Certificate of Appropriateness

2504 N. Grant Boulevard, Grant Boulevard Historic District

Dismantle the existing chimney down forty-two (42) courses and rebuild the chimney to the original height with bricks and mortar to match the original appearance. Type N mortar to be used throughout. Rebuild poured concrete cap to match existing.

Existing chimney

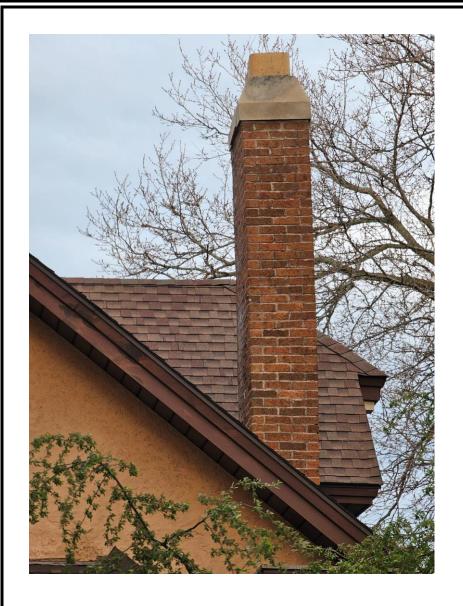
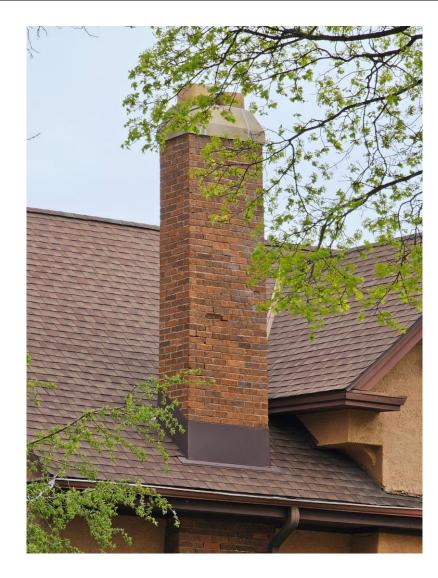
New mortar must match the original mortar in terms of color, texture, grain size, joint width, and joint finish/profile. The compressive strength of the repointing mortar shall be equal or less than the compressive strength of the original mortar and surrounding brick or stone. The replacement mortar shall contain approximately the same ingredient proportions of the original mortar. Mortar that is too hard is subject to premature failure and could damage the masonry. See the city's books *As Good As New* or *Good for Business*, Masonry Chapters, for more information. In most cases, this means a lime mortar with natural hydraulic cement rather than Portland cement. No joint of a width less than 3/8" may be cleaned of damaged/decomposed mortar with power disc grinders. No over-cutting of the joints is permitted. Remove decomposed mortar back into the wall 2.5 times the height of the joint before repointing. When installing new flashing at a masonry feature, the flashing must be stepped or cut into the mortar joints. The bricks may not be cut to install flashing at an angle.

New brick/stone/terra cotta must match as closely as possible the color texture, size, and finish of the original.

A sample panel of the masonry materials and their mortar must be reviewed and approved by HPC staff prior to general installation of the material.
